## URGENT FIELD SAFETY NOTICE

Commercial Name: CoolSculpting® Elite System  
Device Reference: CS-S3-001-D-00 or CS-S3-001-I-00  
FSCA/FSN Reference: FSCA-21-001-CSElite/FSN-21-001-CSElite  
Type of Action: Device retrofit (new software release)  
Serial Numbers: XXX  
Associated Devices: Surface 150 (S150) Applicator (CS-A3-15S-00)

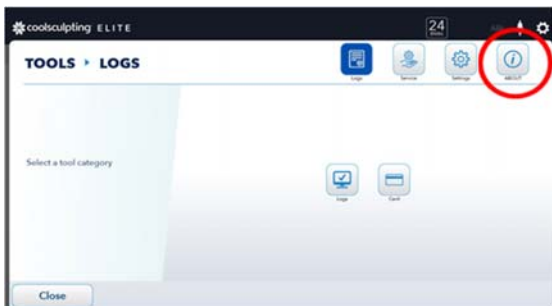
1. Press the Tools icon on the top right of the screen.

2. After selecting Tools, select the ABOUT button.

3. Scroll if necessary and check that the Software Release field shows version 3.1.0.
